**PRELIMINARY DRAINAGE REPORT**  
for  
**THE COMMONS AT FALCON FIELD**

**June 29, 2023**

**PCD FILE NO. SP-232 ●**

**EDR1**

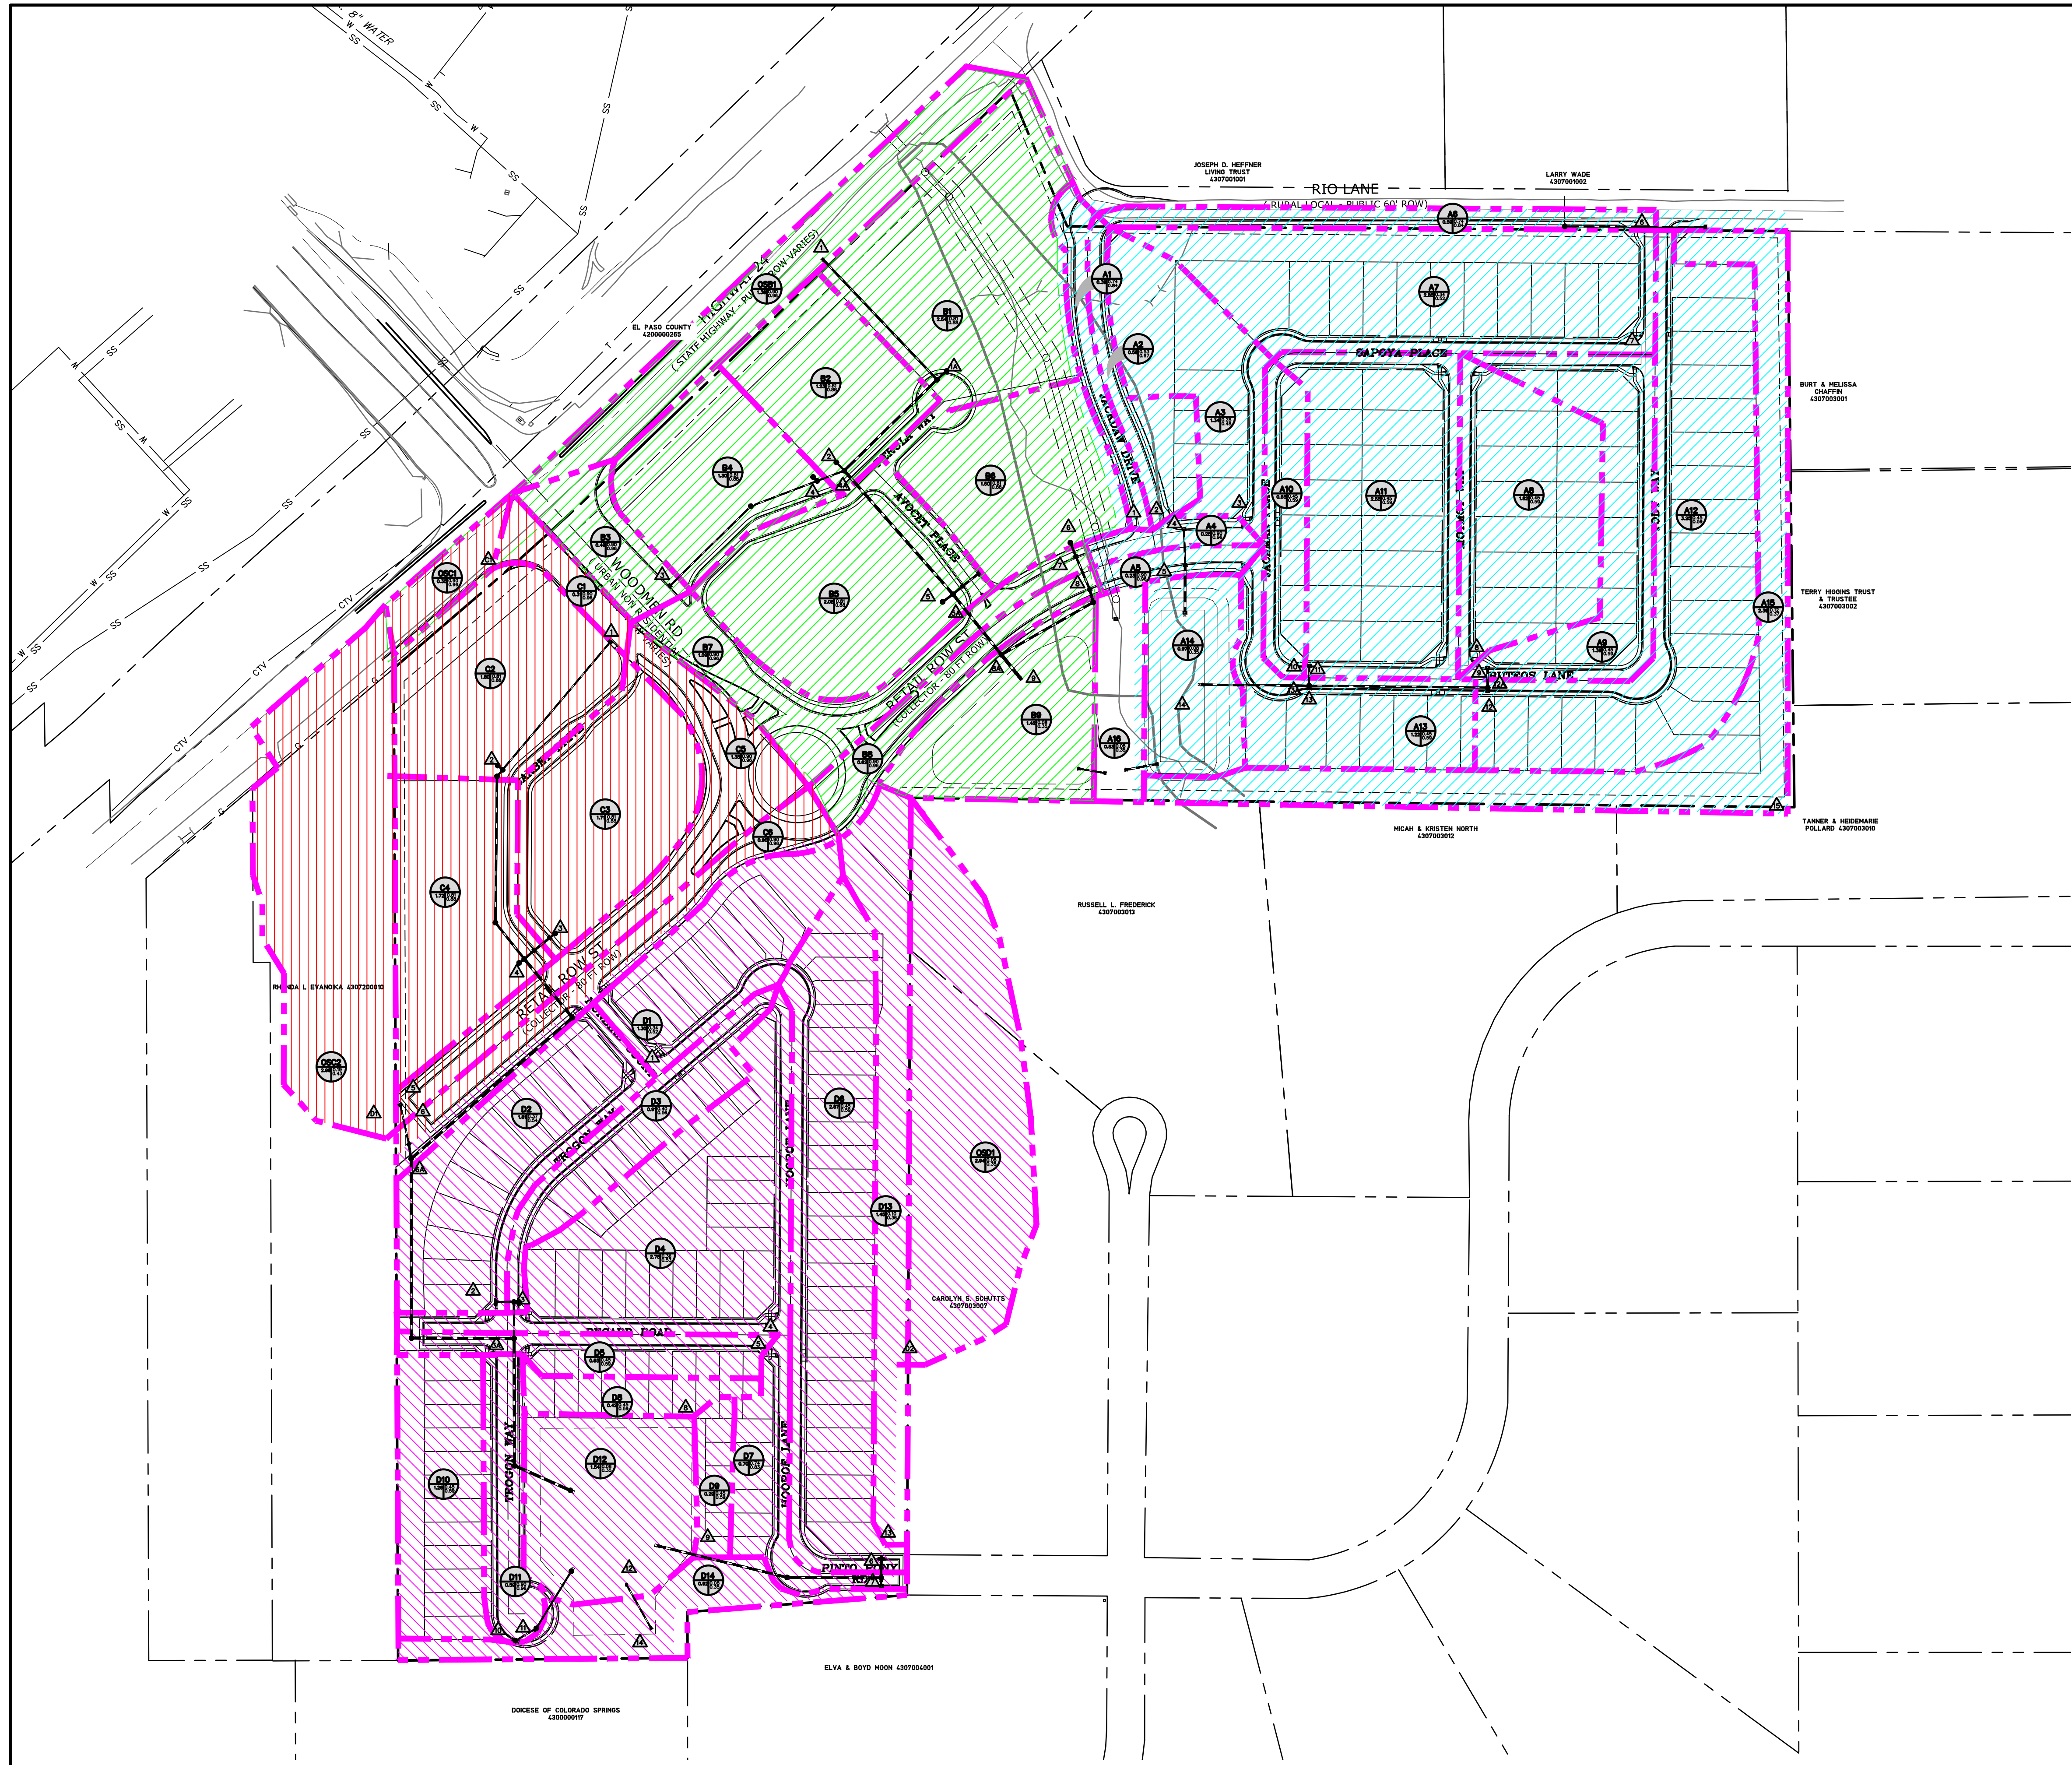
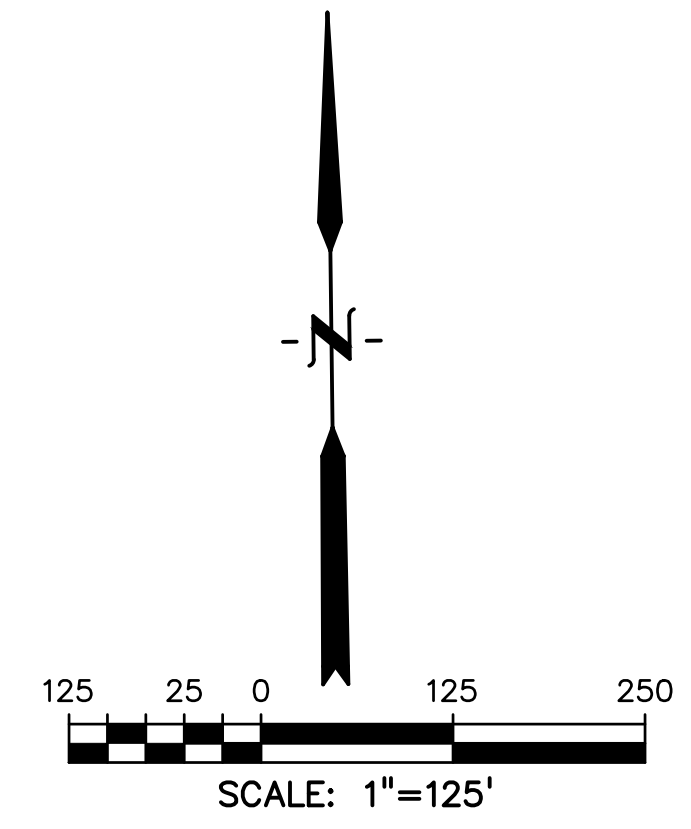
- LEGEND**
- - - - EX. MINOR CONTOUR
  - - - - 6800 EX. MAJOR CONTOUR
  - — — PR. MINOR CONTOUR
  - — — 6800 PR. MAJOR CONTOUR
  - — — STORM DRAIN
  - — — EX. STORM DRAIN
  - — — BASIN BOUNDARY
  - ← FLOW DIRECTION
  - ▲ DESIGN POINT
  - BASIN
  - E5
  - C5
  - C100
  - AREA (ACRE)
  - 5.91
  - 0.12
  - 0.36
  - A-BASINS
  - B-BASINS
  - C-BASINS
  - D-BASINS
  - shade SPA areas separately

**DR1**

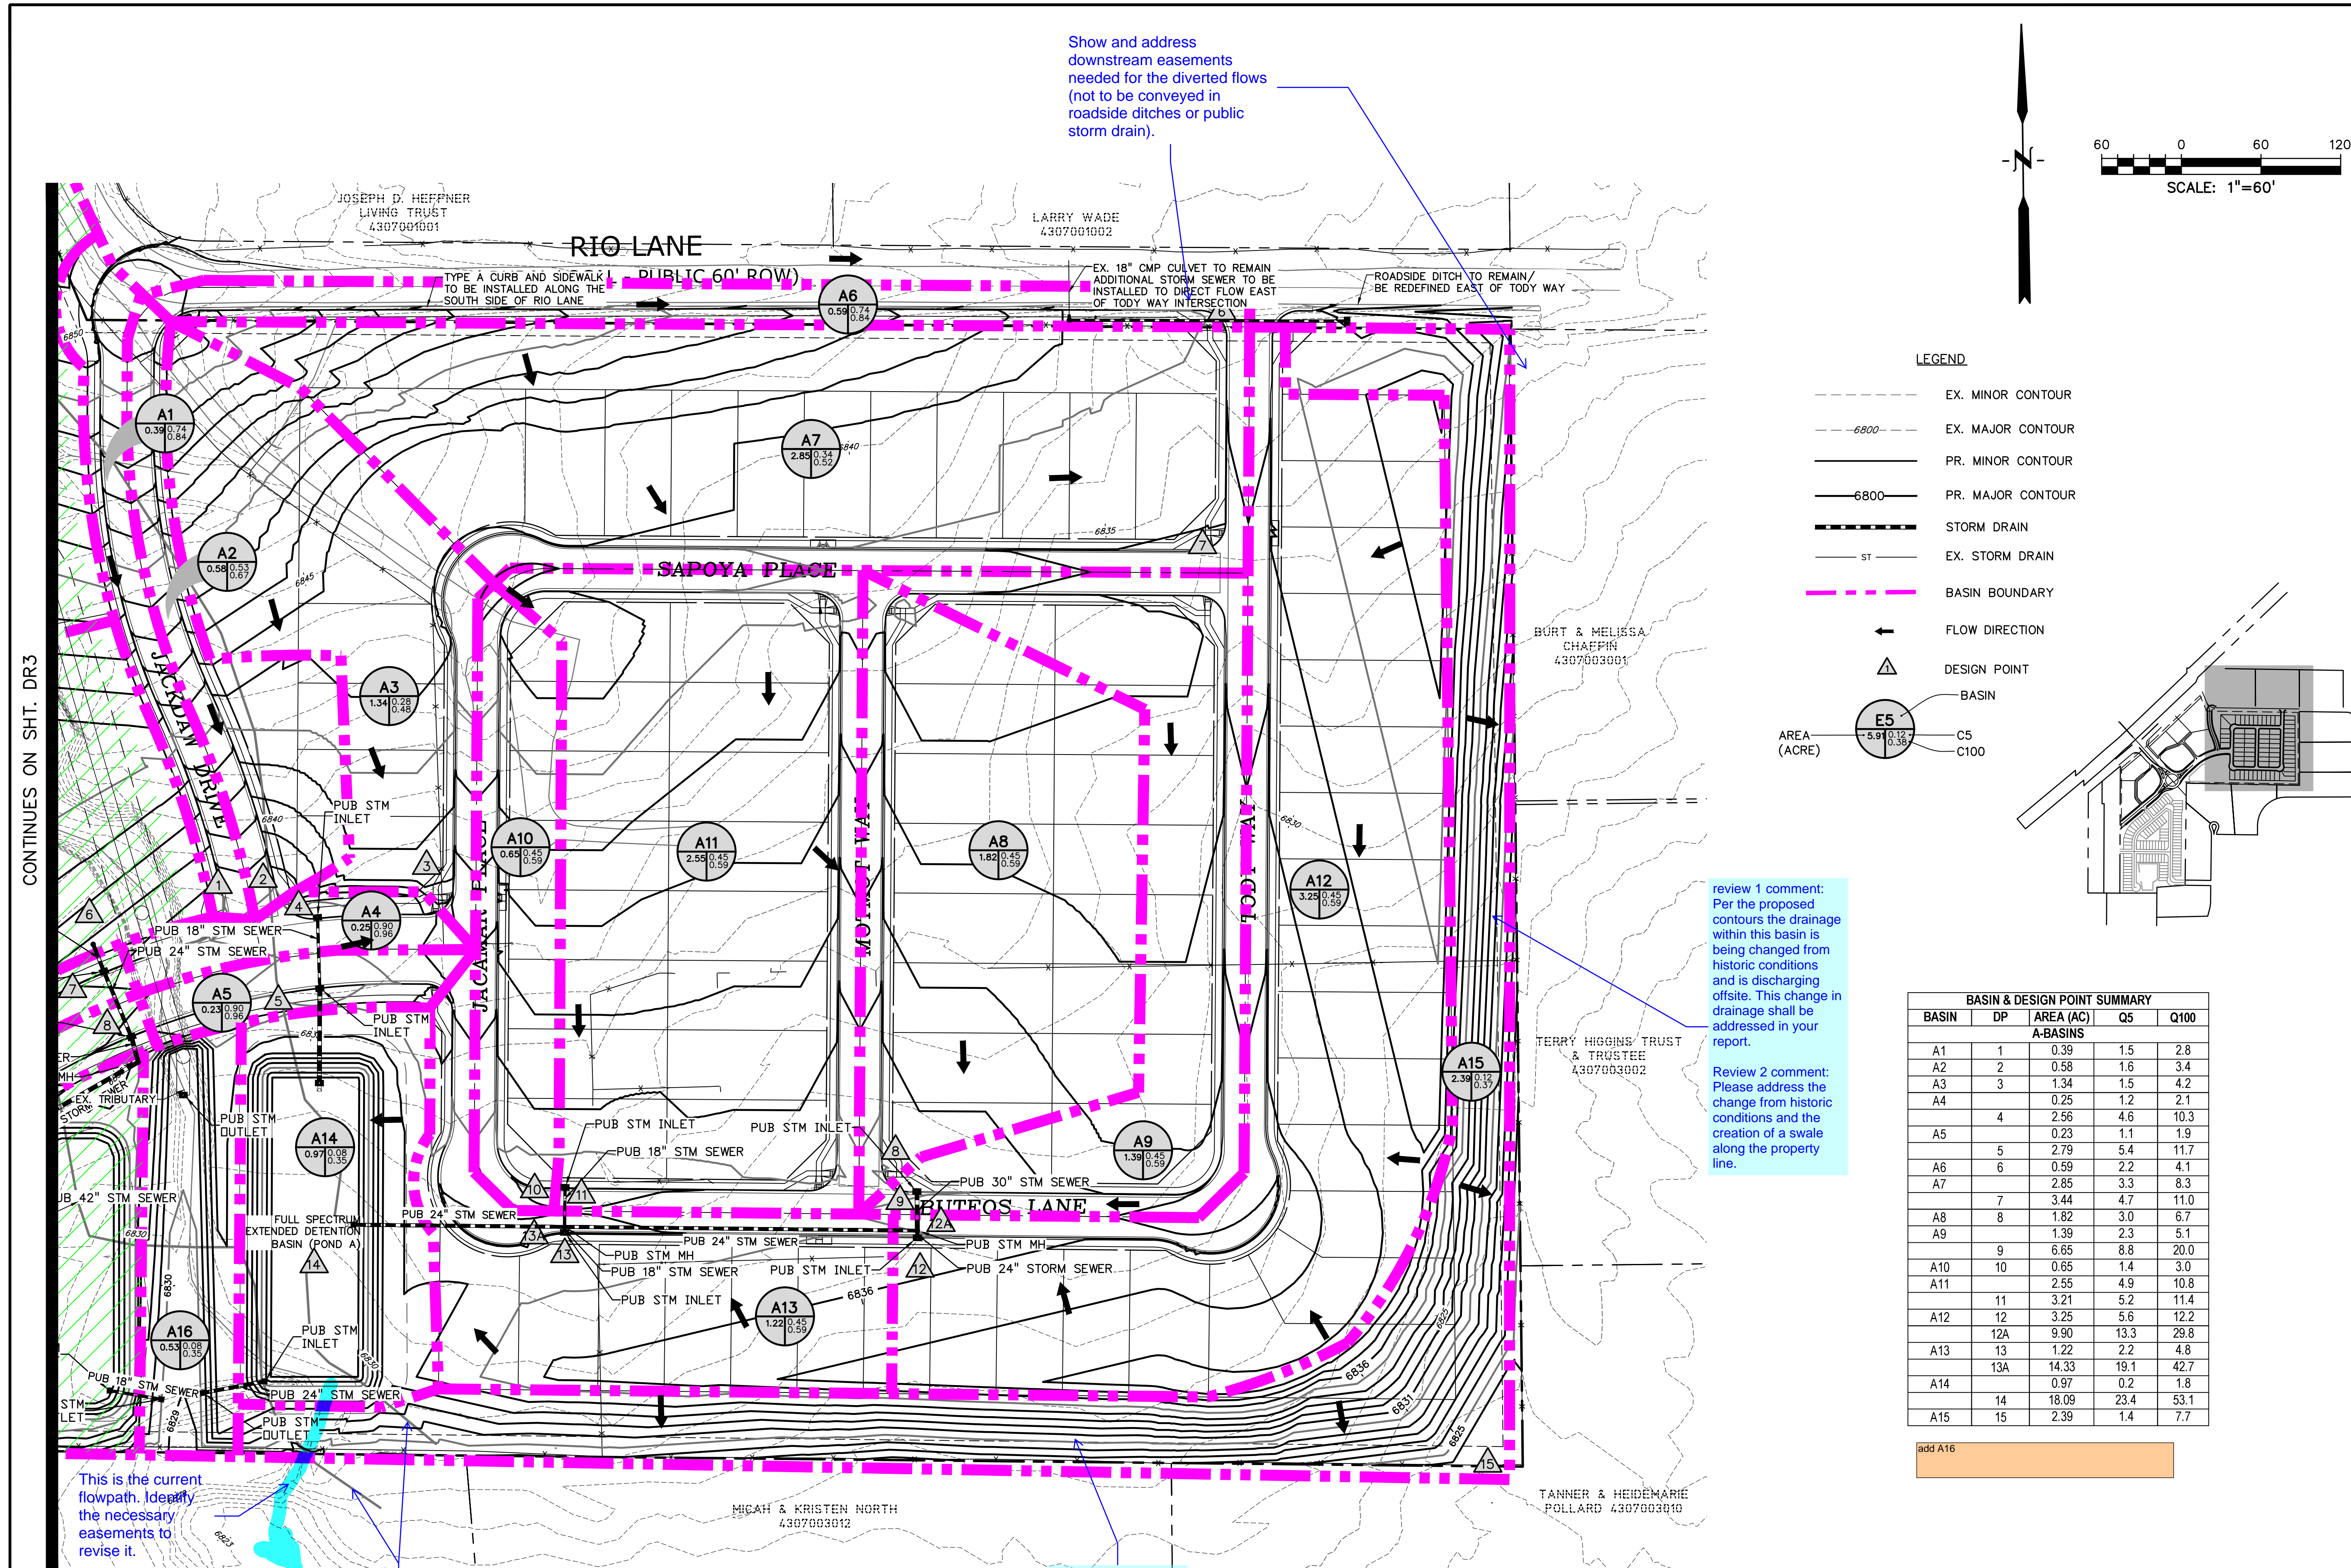
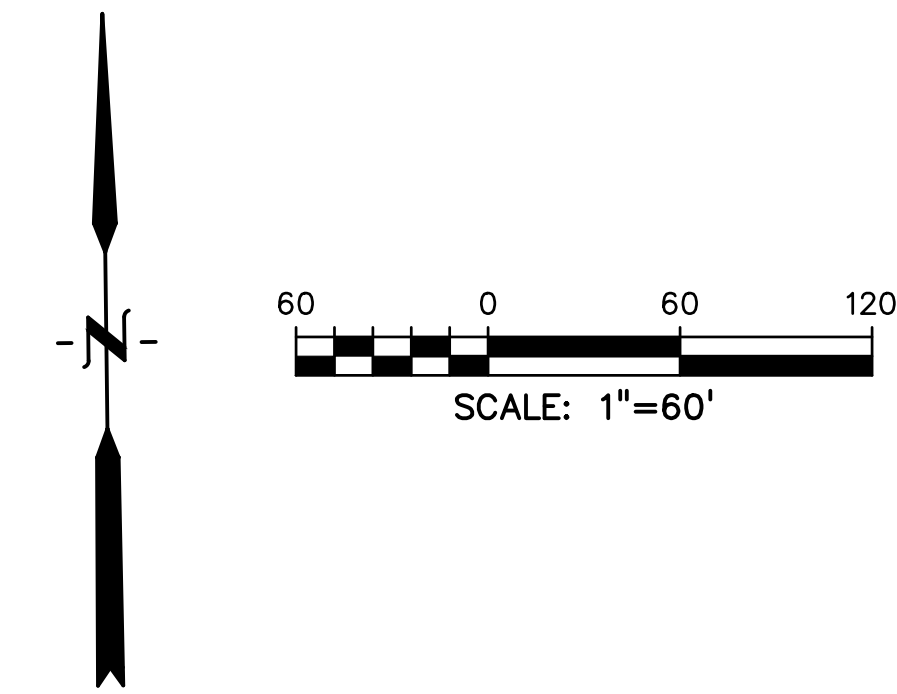
Show and address downstream easements needed for the diverted flows (not to be conveyed in roadside ditches or public storm drain).

review 1 comment: Per the proposed contours the drainage within this basin is being changed from historic conditions and is discharging offsite. This change in drainage shall be addressed in your report.

Review 2 comment: Please address the change from historic conditions and the creation of a swale along the property line.

This is the current flowpath. Identify the necessary easements to revise it.
